LAND WEST OF BILSHAM ROAD (PLANNING REF: Y/3/22/OUT)

We refer to the Drainage Engineer's email response to the above planning application and provide the below response.

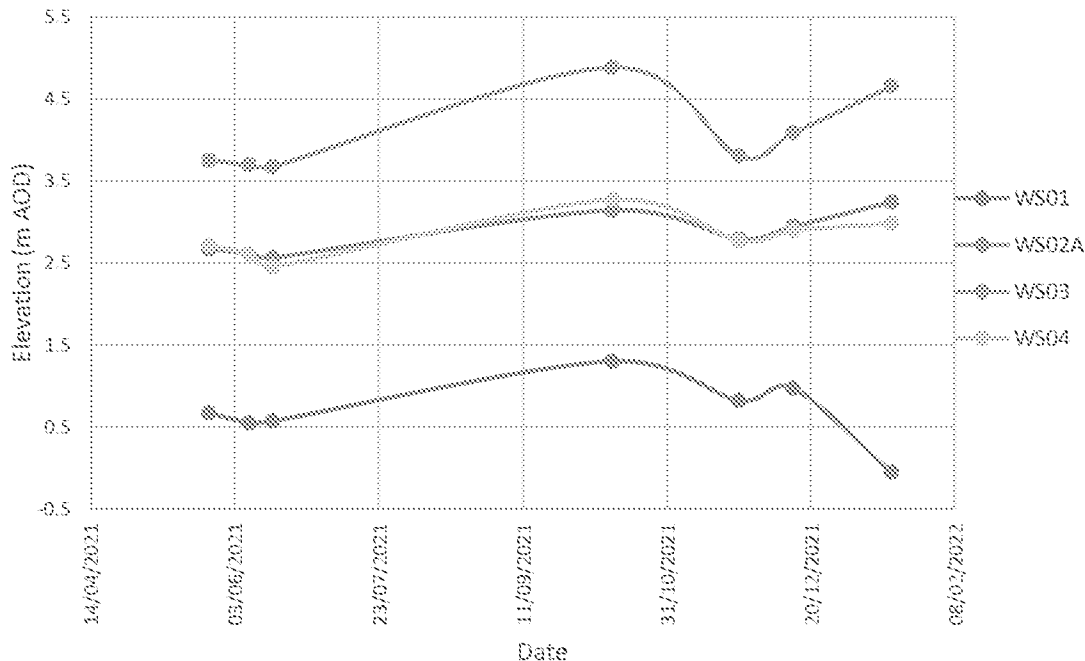
The groundwater level rose between 0.53m and 0.75m in WS01, WS02A and WS04 while the level within WS03 rose 1.19m. The greater increase in WS03 is likely due to the cohesive composition of the response zone (firm clay) within the hole, the lower permeability and hence the greater the build-up of water. The other installations have a response zone comprising sand which would account for the reduced increase in groundwater level as the water is able to drain away at a faster rate.

With the exception of WS01, following 12th October 2021 the groundwater levels reduced towards their initial level and then increased again into January 2022. WS01 however reduced in elevation after 14th December which is potentially due to a more granular material being present within the response zone. The borehole log records the material as "becoming loose" at 1.2m bgl (0.67m AOD) and "gravelly" from 2.0m bgl (-0.13m AOD), hence the material becomes more porous and the water is able to readily disperse within the granular material.

The groundwater level varies between 0.57m bgl and 2.41m bgl across the site as shown in the chart below.
